Final Environmental Impact Statement

**Amsterdam Materials Recycling Project
Edson Road
City of Amsterdam, Montgomery County, New York**

February 20, 2007

Response to Public Comment

CONSTRUCTION GRADING PLAN

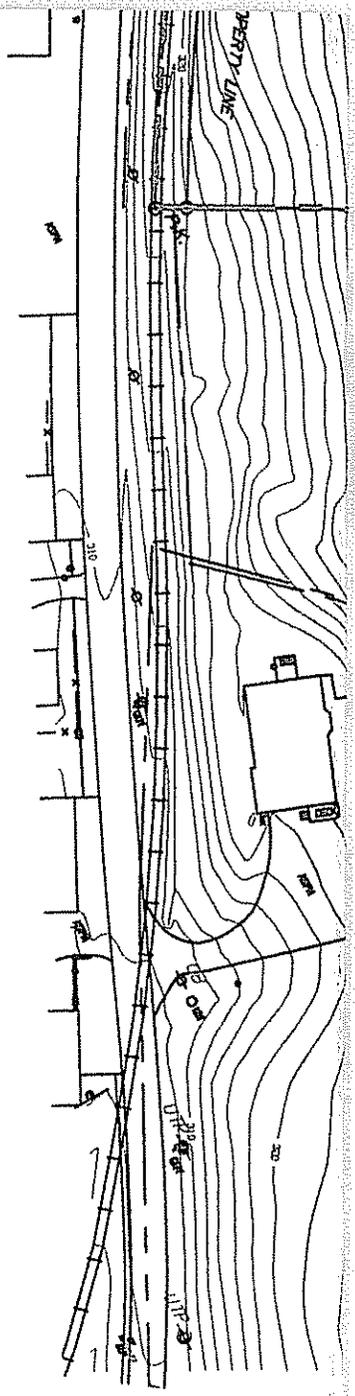
Section 2.2 of the DEIS provides a general description of the landfill construction activities and sequence. To address public comments in these areas, Section 2.2 has been revised to provide a clearer description of the landfill construction activities. In addition, Figure 2.3 has been modified and incorporated as Figure 2.2, depicting the landfill excavation phases.

At this time it is anticipated that the clearing and excavation phase of the project will begin in the southern portion of the proposed cell area moving northwest, with three distinct phases, as shown on Operational Grading Plan, Figure 2.2. Working in this manner allows for additional maintenance of storm water controls and minimizes erosion.

LEACHATE COLLECTION SYSTEM PLAN

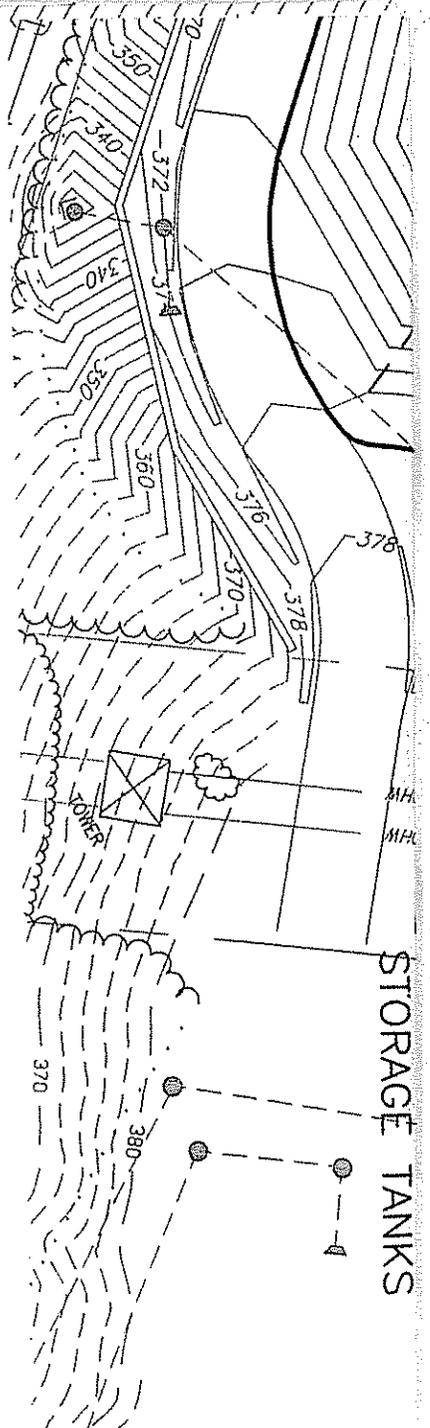
The leachate storage system designed is capable of managing the 25-year, 24-hour design storm required by regulation. Comments were received during the public comment period regarding the configuration of the leachate management system and the capability of the system to handle storms larger than required by regulation or to handle smaller storms occurring just after a larger storm.

In response to public comment, The leachate collection system has been modified, Figures 3.17 and 3.18 have been added to the DEIS, and the following additional descriptions have been added to Section 3.18 of the DEIS:

The configuration of the proposed inter-cell berms and the leachate collection system is shown in the Leachate Collection System Plan, Figure 3-17. In general, waste disposal operation will begin in the eastern portion of the landfill, Cell 1, and proceed to the west, into Cells 2 and 3.

BEDROCK EXCAVATION PLAN

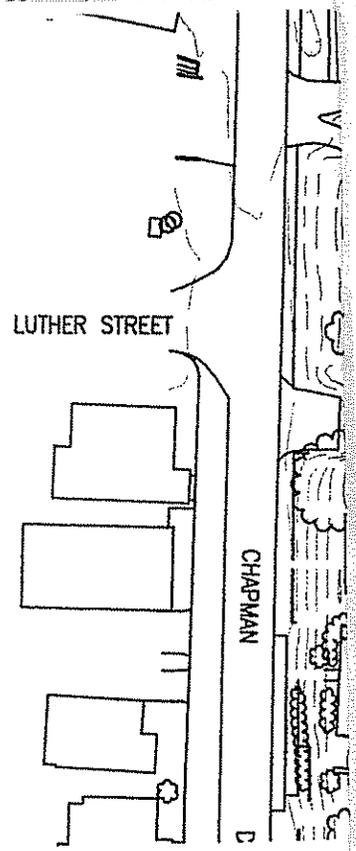
Numerous comments were received requesting addition information on the proposed bedrock blasting protocols, potential risks to the neighborhoods around the blasting site, and mitigation measures to reduce or eliminate the potential risks. To address these comments, the following modification to the DEIS have been made:

The estimated limits of bedrock removal and the grades for the final excavation are shown in Figure 3-3.1, Bedrock Excavation Plan and representative cross-sections are shown in Figure 3-3.2, Bedrock Excavation Cross-Sections.
